## PREFERRED PROJECT REPORT

This Preferred Project Report (PPR) sets out the changes to the project since exhibition, arising in part from submissions made, and from further consultation with stakeholders including community representatives, the City of Sydney Council, and Dragon Boats NSW.

Figure 1 – Exhibited Fixed Wharf Design

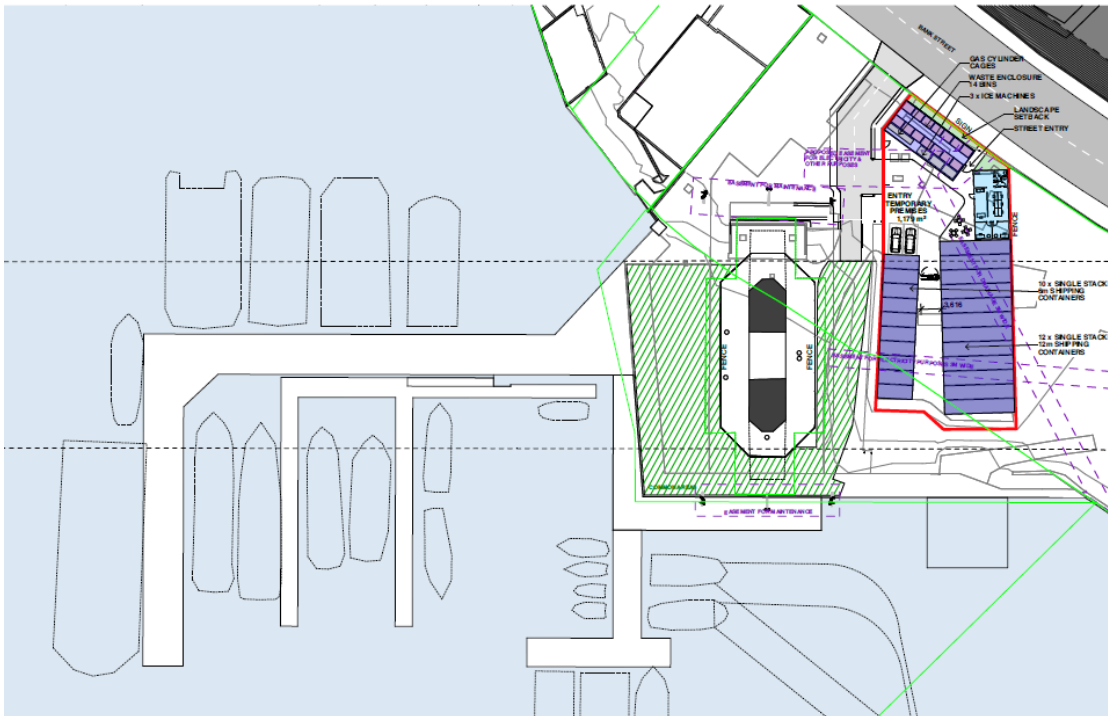
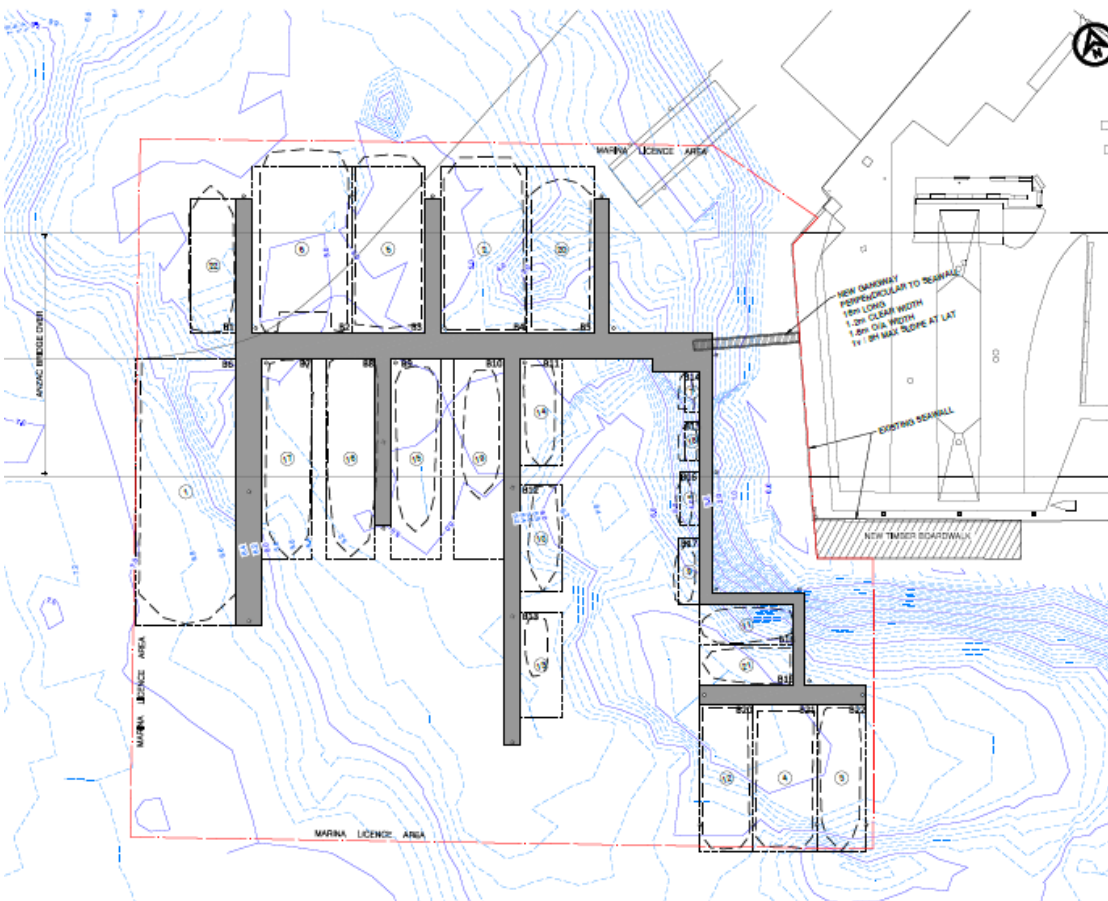
Since the exhibition of MOD 3, UGDC now proposes a marina layout comprised entirely of floating pontoons connected to shore by a single gangway attached to the western shoreline (refer Appendices A and F of the Royal HaskoningDHV Navigation Impact Assessment at **Appendix C** of this RIS / PPR package and figures below).

The figures show the exhibited fixed wharf configuration and assumed vessel mooring location of the BBM fleet (Figure 1) and then the floating pontoon arrangement enabling a more flexible outcome which removes vessel turning movements towards the Dragon Boat launching ramp, locates larger vessels to the west away from the Dragon Boat launching area, and enables the licence area to be revised to be smaller, again away from the Dragon Boat launching area (Figure 2).

The positions of vessels have been amended (as compared to the proposed berthing positions within the s75W Modification Application under the fixed wharf arrangement). This now provides a more efficient berthing / mooring arrangement and reduces interaction and conflict with the Dragon Boat launching ramp to the east. The reduced piling requirement for the floating structure also reduces impacts on the seabed during construction. Appropriate placement of vessels will further reduce seabed disturbance compared to the notional mooring arrangements under the fixed wharf design during operation of the marina.

Figure 3 – Potential substation location and easement zone

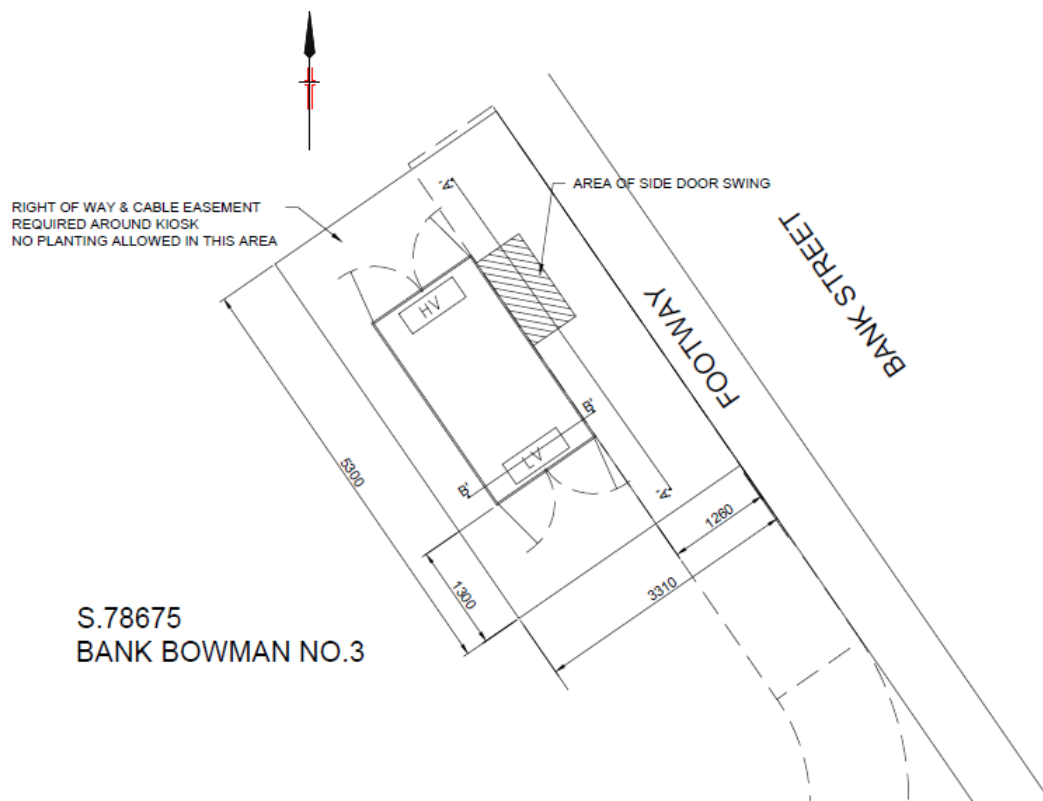
An L type kiosk electricity substation is proposed to be established in the north-eastern corner of the site, adjacent to the Bank Street frontage of the site and the existing wall of the building at 1-3 Bank Street. The final location is still to be determined and will be based on optimising its connection to existing services and operational capacity, and without significantly impacting upon the area of open space, its design or impacts upon neighbours.

The substation will have an easement zone of 3.31m wide by 5.3m long with the substation itself somewhat smaller in dimension (being 2.71m long x 1.475m wide x 1.62m high). The easement will principally enable maintenance access and clearance to open doors and hatches unencumbered, and provide for suitable air-intake for cooling purposes. Principal access to the substation will be via its narrow ends, orientated to the north and south, and its side facing Bank Street – see Figure 3 below.
